Value Engineering Study

Final Report

VE Number: 202303

I-75 Widening, MP 20.2 to MP 28.851 Laurel & Whitley Counties

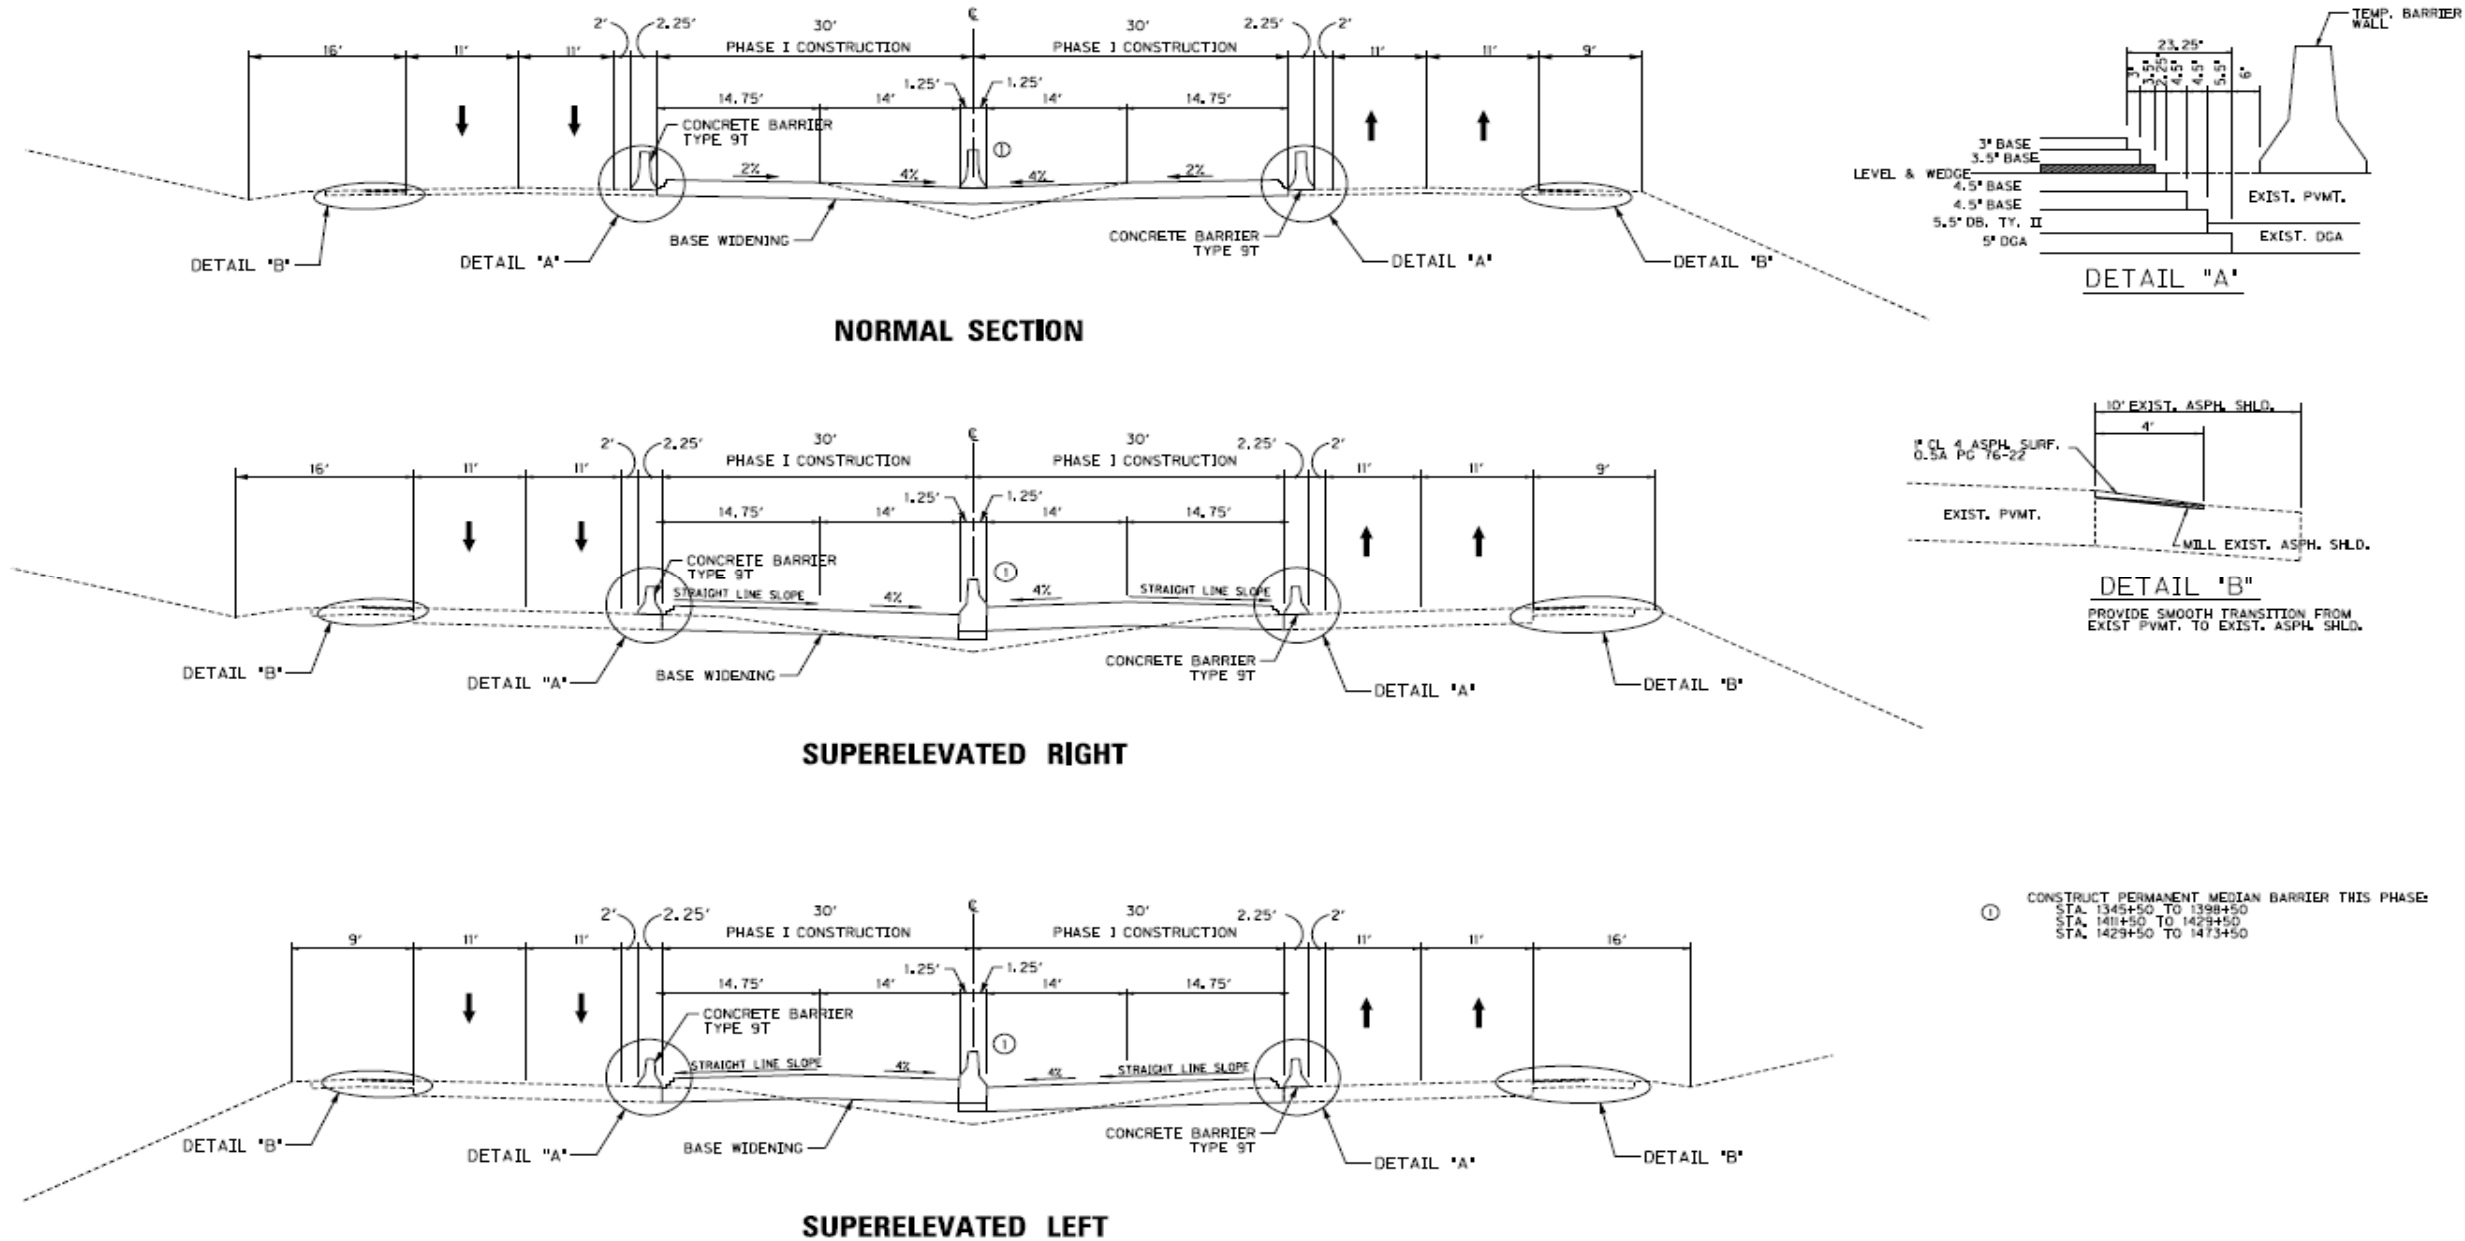
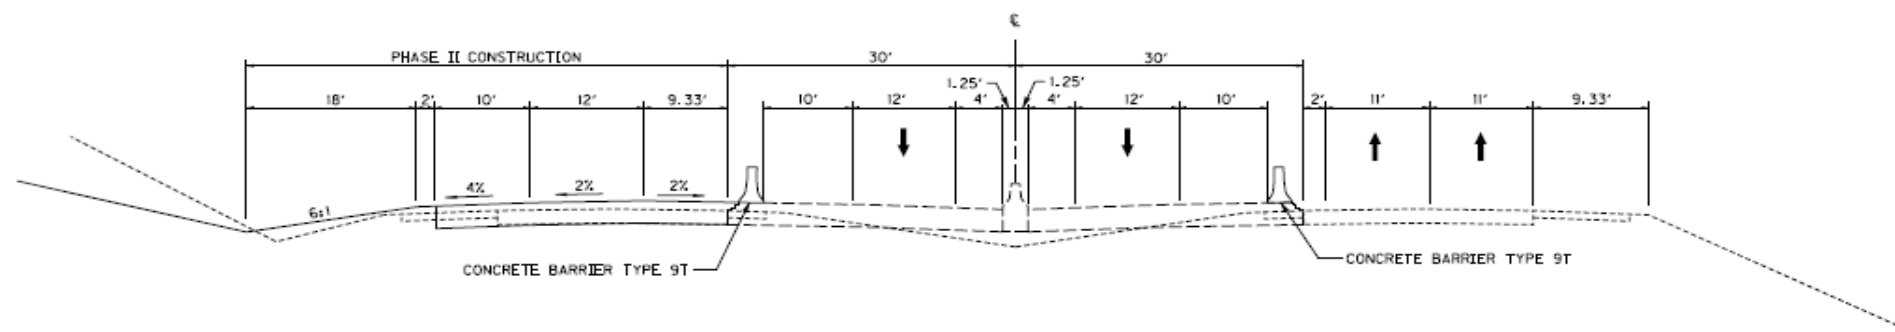
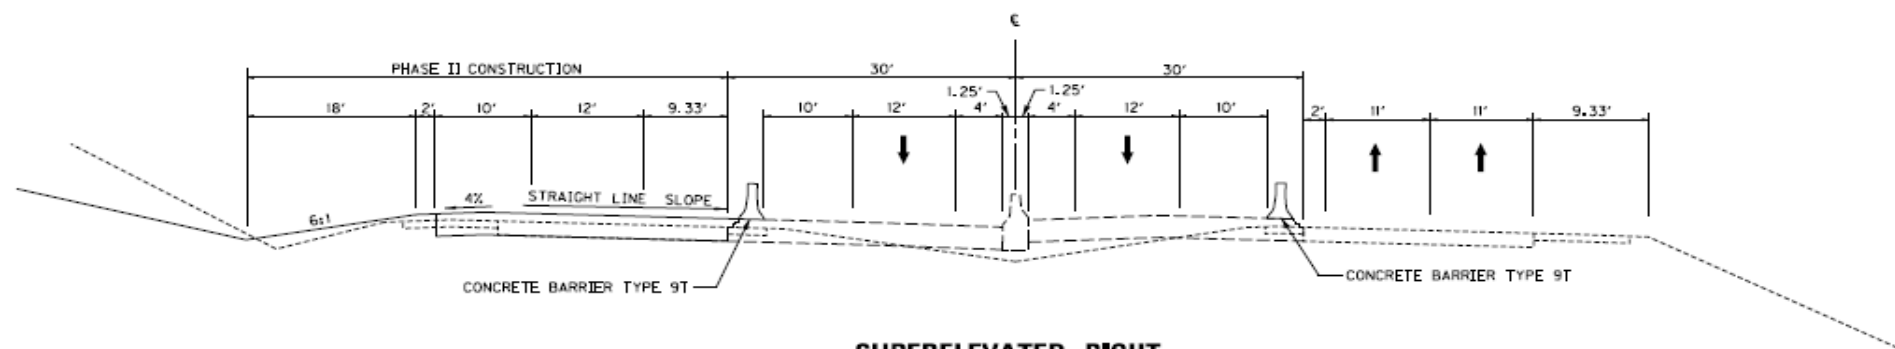
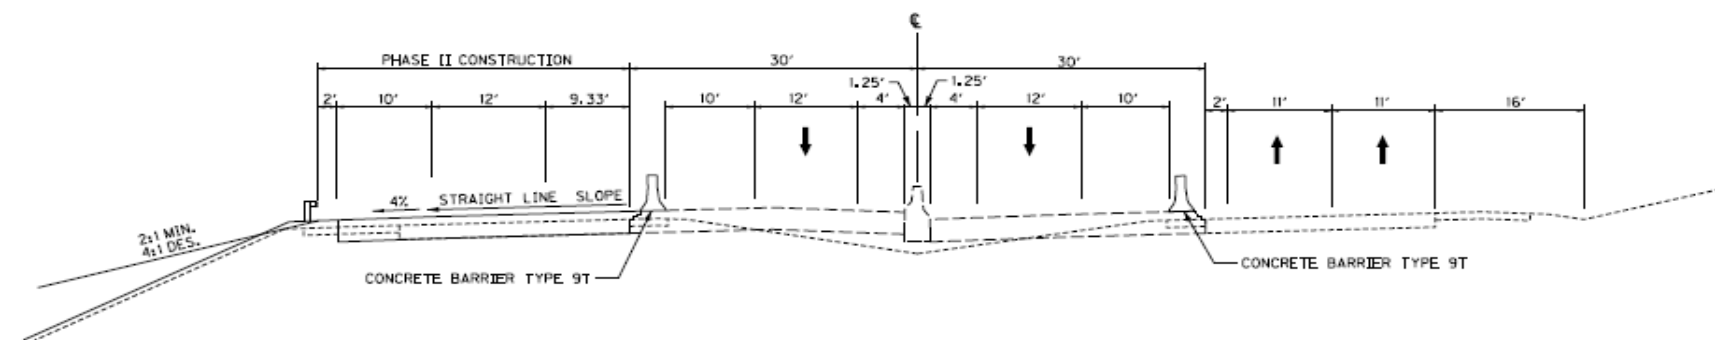
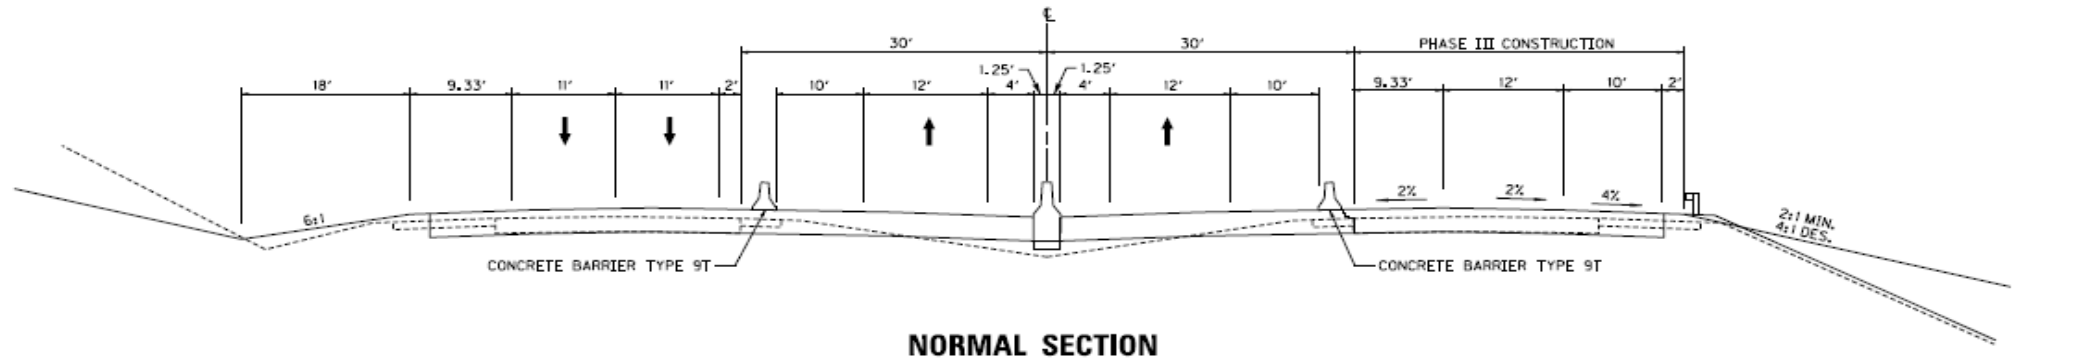
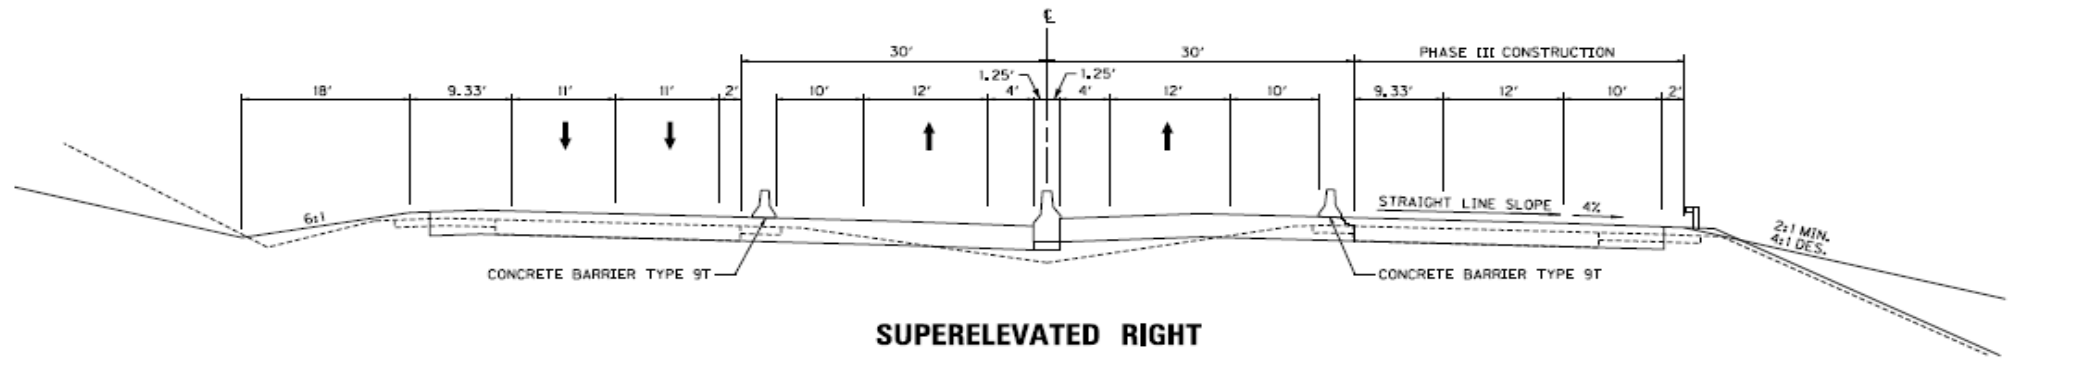
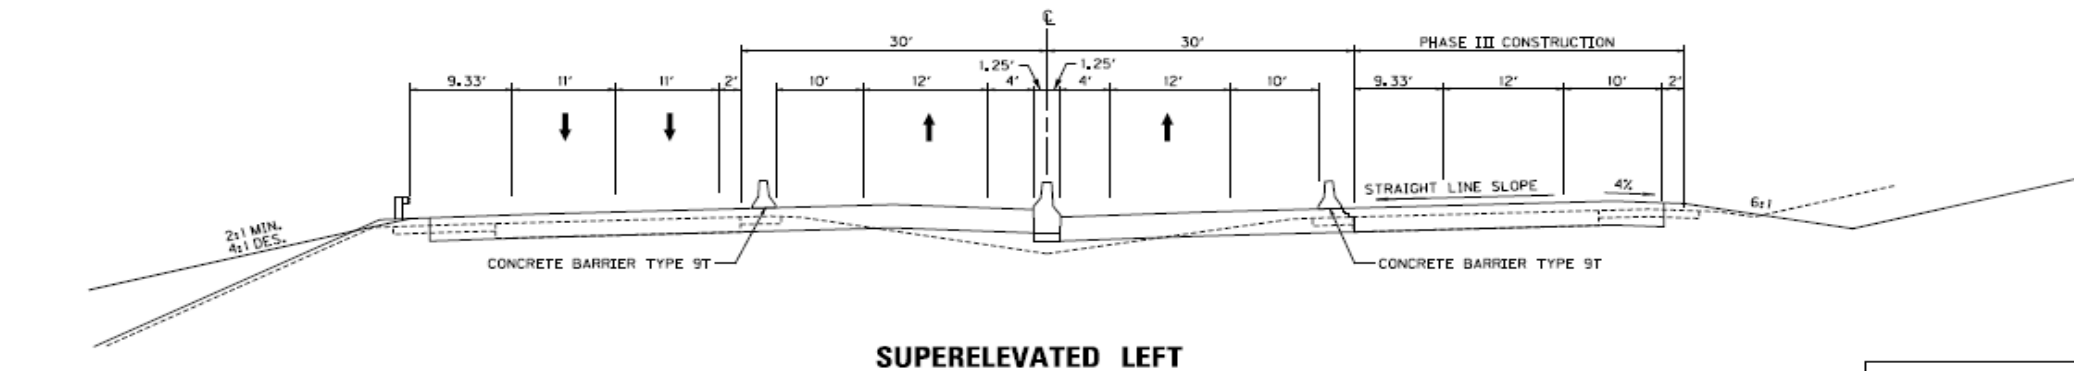
TITLE	Widen one structure on Lynn Camp Creek Bridge to provide 4 lanes of traffic (2 in each direction) in order to minimize construction phasing on the second structure
--------------	---

TITLE	Widen one structure on Lynn Camp Creek Bridge to provide 4 lanes of traffic (2 in each direction) in order to minimize construction phasing on the second structure
DISCUSSION & JUSTIFICATION:	
<p>Construction of the piers for the widening will take a considerable amount of time each. With the contractor forming and pouring about 20' at a time, we are estimating approximately 6 months each side for the substructure. By building one direction in 2 phases, we allow for complete demolition of the other bridge. The limiting factor for a vertical pour is the height. The contractor would be able to form and pour all the substructure for each lift as opposed to splitting it up. This could in turn lead to a different pier design on the second structure since the existing bridge will be completely removed first.</p> <p>By building the structure as one unit instead of phasing, you can eliminate the longitudinal construction joint in the pier, the longitudinal construction joint in the deck, the phased placement of armored edges and joint material. All this can be done while not impacting the traveling public at all. 2 lanes can be maintained on the new structure built in phase 1 and 2.</p> <p>The contractor will be able to stage material for the second bridge in the closed portion of interstate, receive beams safer, minimize any crane pads needed below (would only need one pad per pier instead of two). There is little doubt that the Lynn Camp Creek bridge will be the critical path for the project. By eliminating the 2 phase from the second bridge we immediately save 6 months off the construction.</p> <p>While crossovers do cost money, the logical locations for cross overs can exist in the areas just north and south of the bifurcated areas, allowing the majority of temporary pavement needed to actually line up with permanent pavement.</p> <p>The cost to construct these cross overs is minimal when compared with time savings and joint elimination which is one of the main locations where we see bridges begin to deteriorate.</p> <p>The cost estimate reflects a price change in concrete class A and concrete class AA. While the typical section of the bridge doesn't change, by reducing the phasing the contractor no longer needs the pump truck for those two phases. They also no longer need the bidwell and deck pour crew for two phases, just one. The production rate of the crew can increase because the contractor can form twice as much as they normally would during phased construction (due to vertical limitations).</p> <p>The median cross over is assuming leveling and wedge at 3" average depths to obtain super elevations. Assuming a 50 median width, and a length of 2000' at 26' width, that equates to \$88,000 per crossover.</p>

Assuming 12' disappears because it will be 3 lanes in the ultimate not 4 as in this plan

MOT Phase 3
58' out to out to maintain 2 lanes in each direction and 2' shoulders across the bridge, 2.25 for temp barrier and 1.5' for perm outside barrier. Assuming new bridge will be 63' out to out.
